TSB 04-15-3

WATER IN THE BLOWER CASE - [BLOWER MOTOR](#)
AND/OR RESISTOR FAILURE - VEHICLES BUILT
5/1/2001 TO 12/15/2003

FORD:
2001-2004 Taurus

This article supersedes TSB 03-15-06 to update the vehicle model years and build date information.

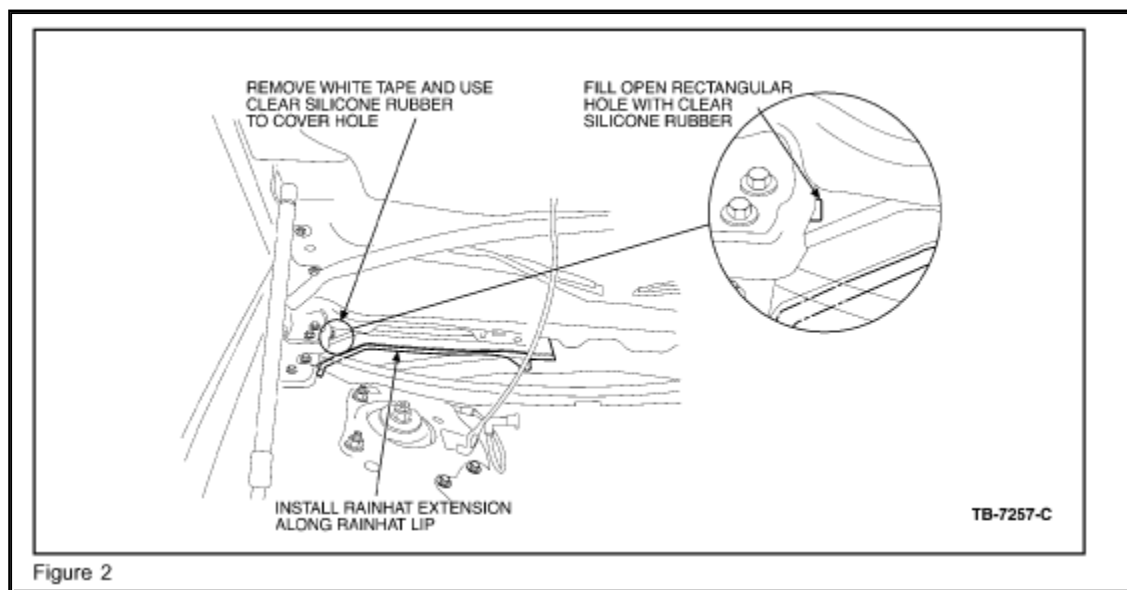
4. Remove the foam sealant expulsion at lower front outboard corner base of the rain-hat (Figure 1).

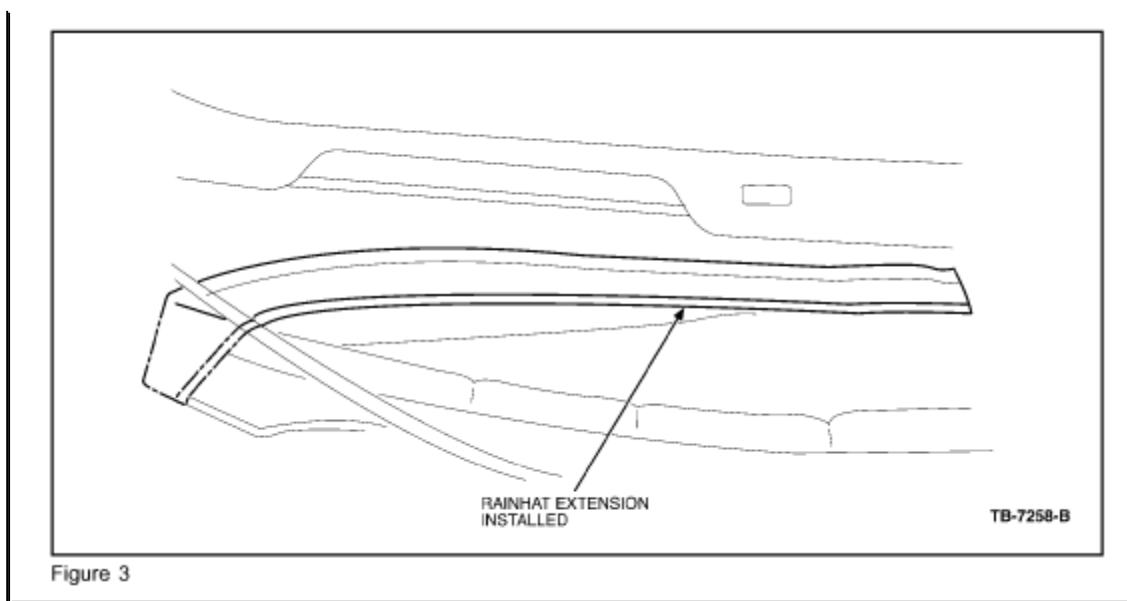
5. Locate the tape as shown (Figure 2). Remove the tape and apply Clear Silicone Rubber TA-32 to the small hole as shown (Figure 2).

6. Install the Rain-Hat Extension Seal or Shed Lip Seal 4F1Z-54022A54-AA to the outboard edge of the rain-hat (see Figure 2 for installation). The 10 mm by 10 mm (0.5" by 0.5") cut area, located 25 mm (1") from the end of the seal, will face down and locate at the 90 degree bend of the rain-hat on the fender side (Figure 3).
7. Prior to installation of the cowl vent screen, verify that the cabin filter cover is properly snapped in place and the clip is located on the inboard side, (toward the center of the bulkhead), the cover will feel loose if not properly snapped in place. Reinstall the cowl vent screen per Section 412-01 of the Workshop Manual.
